<b>ADDENDUM TO THE CONTRACT DOCUMENTS</b>	<b>Page Number</b> <b>1</b>	<b>No. of Pages</b> <b>11</b>
<b>Addendum No. One (1)</b>	<b>Date Addendum Issued: May 12, 2017</b>	
<b>Issuing Office</b> Alaska State Parks, Design & Construction Section 550 West 7 <sup>th</sup> Ave., Suite 1380, Anchorage, Alaska 99501 Phone: 269-8731 Fax: 269-8917	<b>Previous Addenda Issued</b>  <b>None</b>	
<b>Vitro Pit Reclamation</b> <b>Project No.: 52956-1</b>	<b>Date and Hour of Quotes Due</b> <b>May 18, 2017 2:00 pm prevailing time</b>

### **The Contract Documents Are Modified As Follows:**

Project Name: **Vitro Pit Reclamation**

Project Number: **52956-1**

ESTIMATE OF QUANTITIES & LEGEND

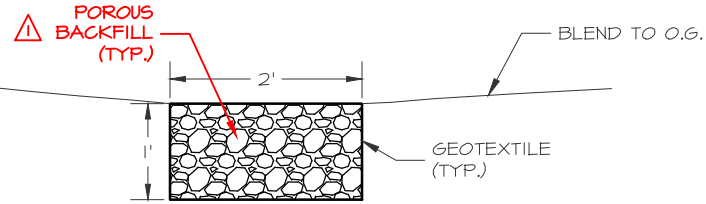
**Delete** Sheet 4 – Estimate of Quantities and Legend and **Replace with** Addendum No. 1 - Attachment F.

ADDENDUM NO. 1 - ATTACHMENT F			
RECORD OF REVISIONS			
NO.	ADDENDUM	DATE	DESCRIPTION
△	1	5/12/17	UPDATED QUANTITIES

UNDERDRAIN DETAILS

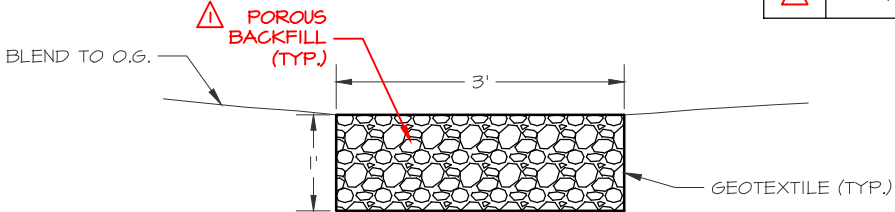
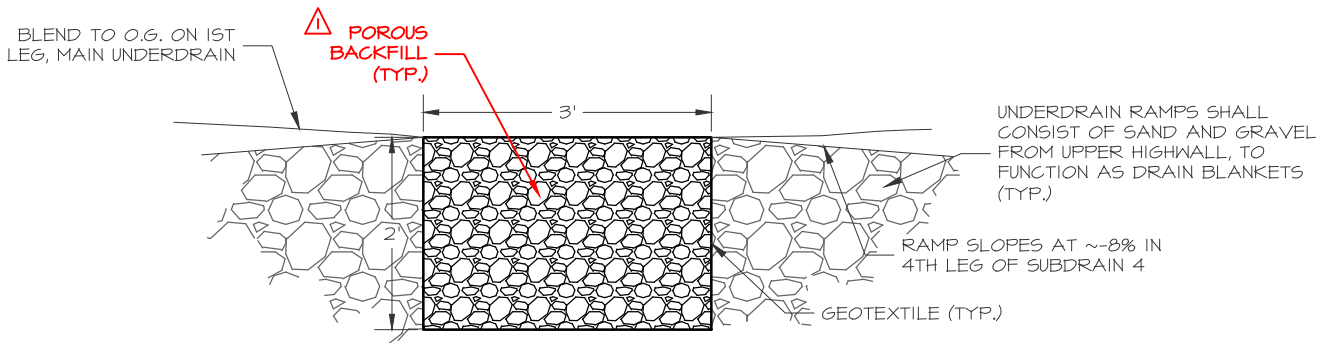
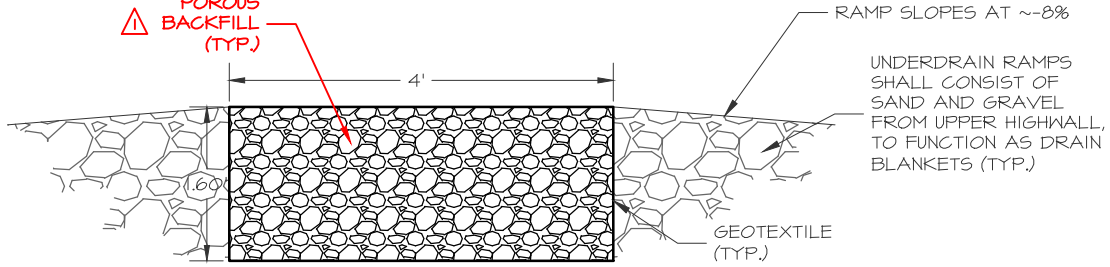
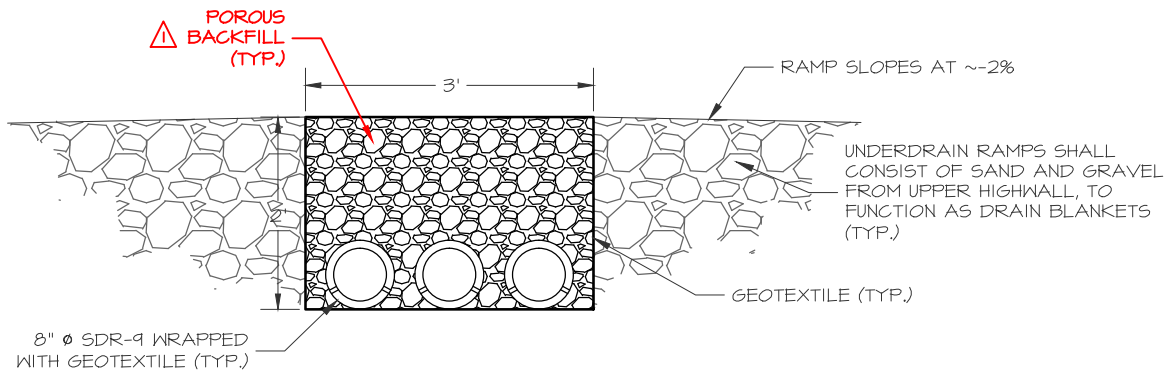
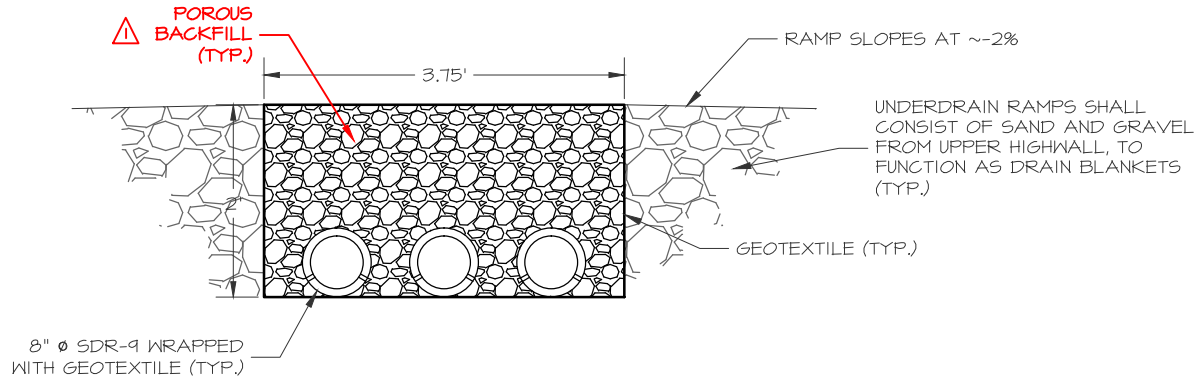
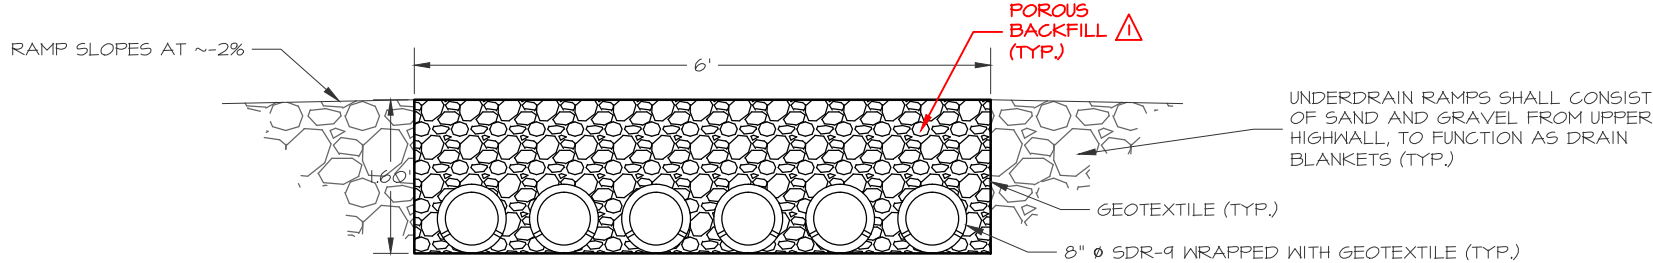
**Delete** Sheet 12 – Underdrain Details and **Replace with** Addendum No. 1 - Attachment G.

ADDENDUM NO. 1 - ATTACHMENT G			
RECORD OF REVISIONS			
NO.	ADDENDUM	DATE	DESCRIPTION
1	I	5/12/17	ADDED POROUS BACKFILL CALLOUTS

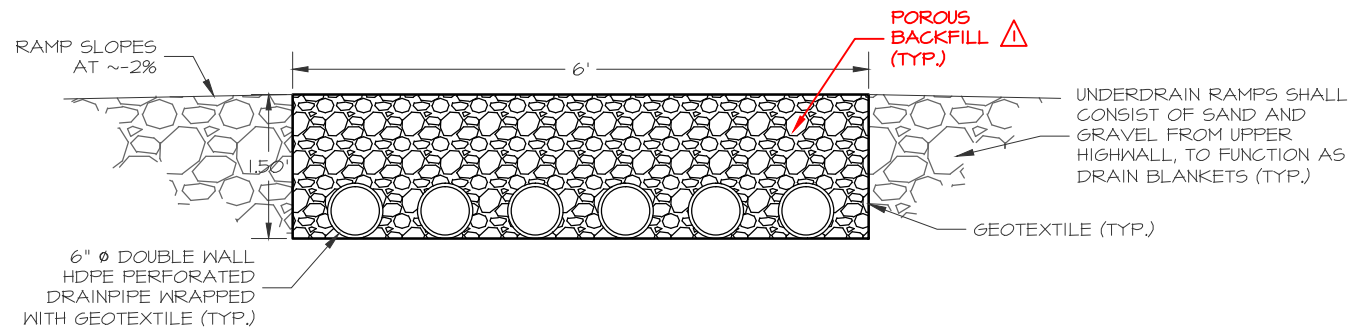
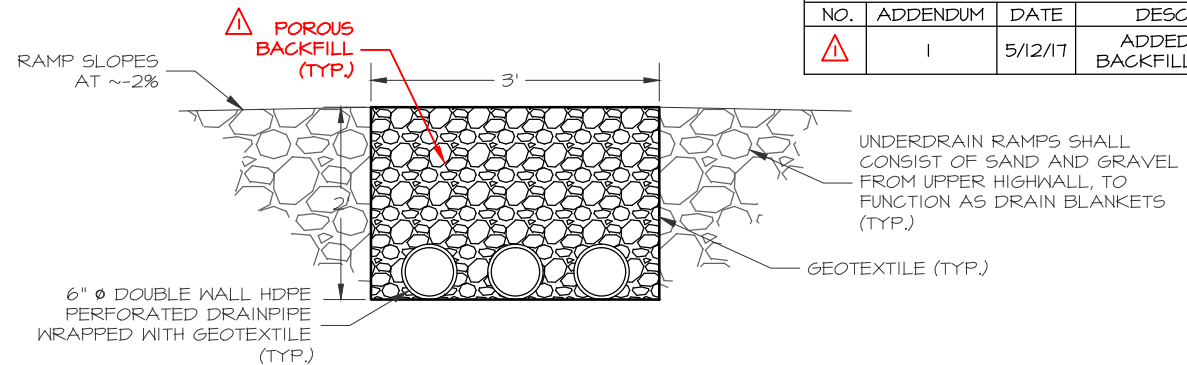
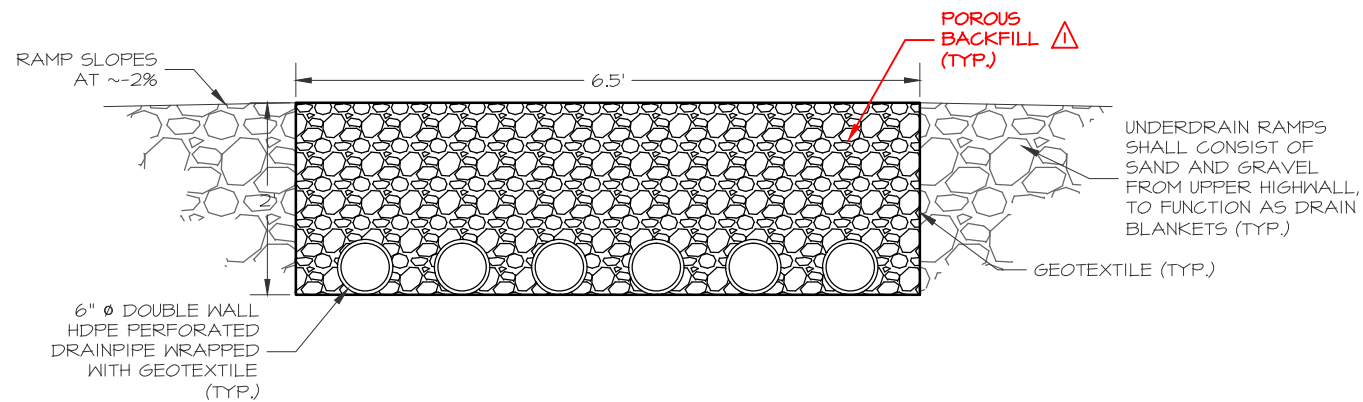
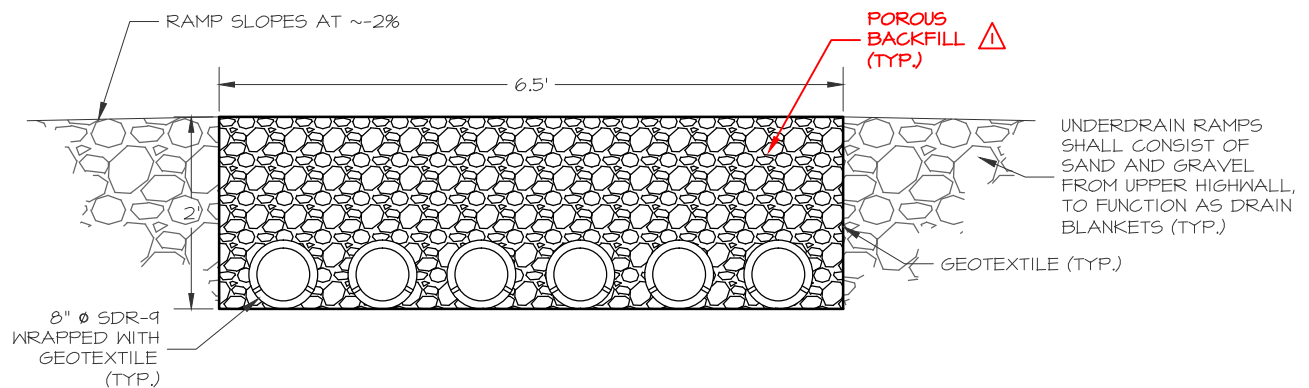
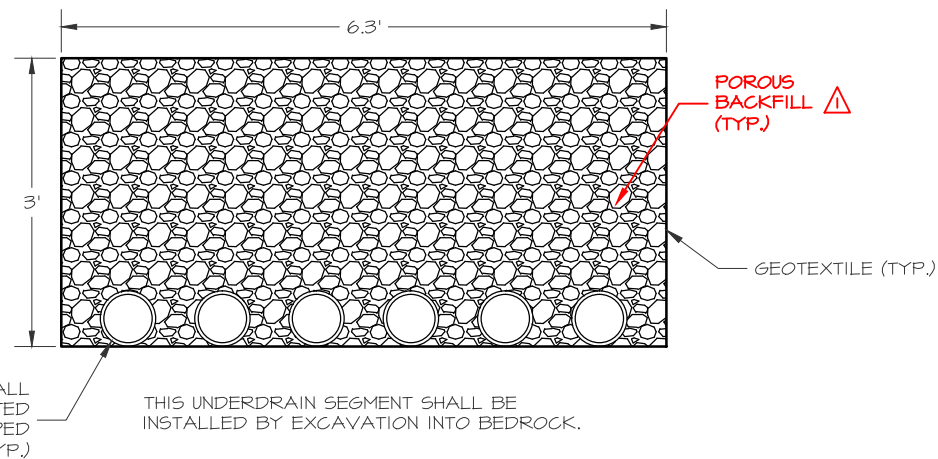
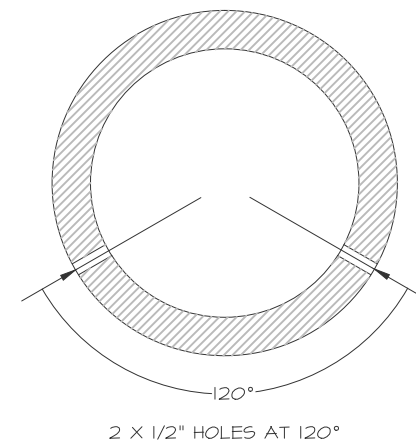
**Delete** Sheet 13 – Underdrain Details and **Replace with** Addendum No. 1 - Attachment H.

ADDENDUM NO. 1 - ATTACHMENT H			
RECORD OF REVISIONS			
NO.	ADDENDUM	DATE	DESCRIPTION
1	I	5/12/17	ADDED POROUS BACKFILL CALLOUTS
